Subject: Duke Energy Corporation  
Catawba Nuclear Station, Units 1 and 2  
Docket Numbers 50-413 and 50-414  
Proposed Change to Technical Specification (TS) 3.7.9,  
Standby Nuclear Service Water Pond (SNSWP)

On July 26, 2005, the NRC electronically transmitted a Request  
for Additional Information (RAI) to Catawba. The purpose of this  
letter is to reply to this RAI. Attachment 1 to this letter  
contains our reply. The format of the reply is to restate each  
RAI question, followed by our response.

**REPLY TO NRC REQUEST FOR ADDITIONAL INFORMATION**

(updated 07/27/05 by Norman Stambaugh)

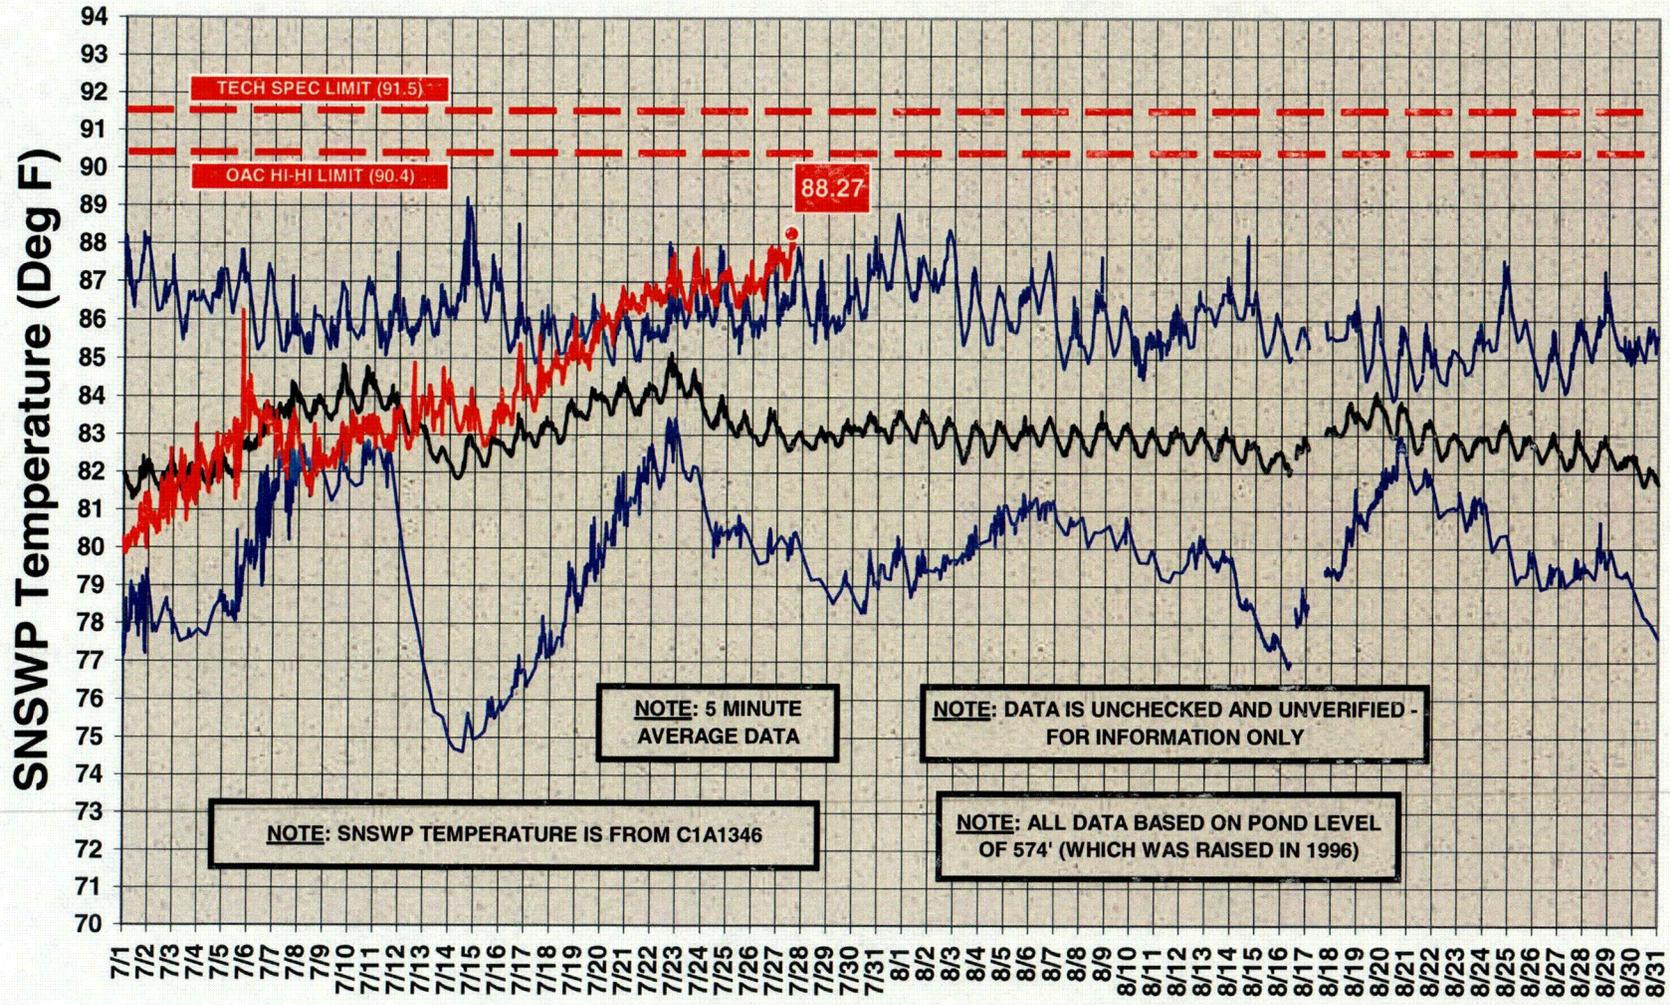
1. Additional information is required in order to demonstrate that the current situation could not have been reasonably anticipated such that an emergency situation pursuant to 10 CFR 50.91(a)(5) exists. Please provide a graphical representation of how the standby nuclear service water pond (SNSWP) temperatures have trended over time (24-hour running average and instantaneous operator/computer values) for the worst two week period of each year since June 1995 to the present, and explain why this information would not cause you to anticipate the elevated SNSWP temperatures that are currently being experienced.

The attached graphs in Enclosure 1 depict how SNSWP temperatures have trended over time during the months of July and August (which includes the worst two-week period of each year for the years 1996 through 2005). There is one graph for each year for 1996 through 2005. The years were chosen to provide a comparison based on the same SNSWP elevation, since elevation can affect measured SNSWP temperature, and elevation was increased to 574 feet in

1996. These graphs utilize 5-minute average data from the Operator Aid Computer (OAC). In addition to graphs for each year, there is also a graph which compares 2005 temperatures with the historical minimum, maximum, and average temperatures for the years 1996 through 2004.

The data in Enclosure 1 indicates short term spikes of up to 89°F during the hot summer months. In the 20 plus years of operating history, there has never been a forced shutdown of a Catawba unit due to SNSWP temperature. Therefore, there was no reason, based on historical data, to anticipate the need for an emergency TS change. However, Catawba did identify the need for additional operating margin in case the historical weather patterns became more challenging. Catawba has been working on the analysis to support this amendment for several months prior to the submittal. Beginning several weeks ago, Catawba began experiencing an extended stretch of hot, humid weather that resulted in an upward trend in SNSWP temperature of approximately 0.4°F per day and increasing Lake Wylie temperatures. Catawba has also historically experienced short term spikes of up to 3°F due to late afternoon rain shower runoff, where the runoff picks up heat from the SNSWP surroundings. Based on the trend, the potential rain runoff concern, and predictions of continued hot and humid weather, Catawba management decided it was prudent to expedite the completion of all required analysis to support raising the SNSWP temperature limit and to submit an emergency TS amendment. In the meantime, Catawba has been aggressively making up to the SNSWP during times of relatively low Lake Wylie inlet temperature in an effort to slow the upward trend in SNSWP temperature. These efforts have slowed the rate of increase of SNSWP temperature. Temperature reached 88.4°F on July 27, 2005. These measures will not be effective indefinitely without a break in the weather. Therefore, continued SNSWP temperature increases over the next few days, and/or a short term temperature spike, could result in exceeding the existing TS limit.
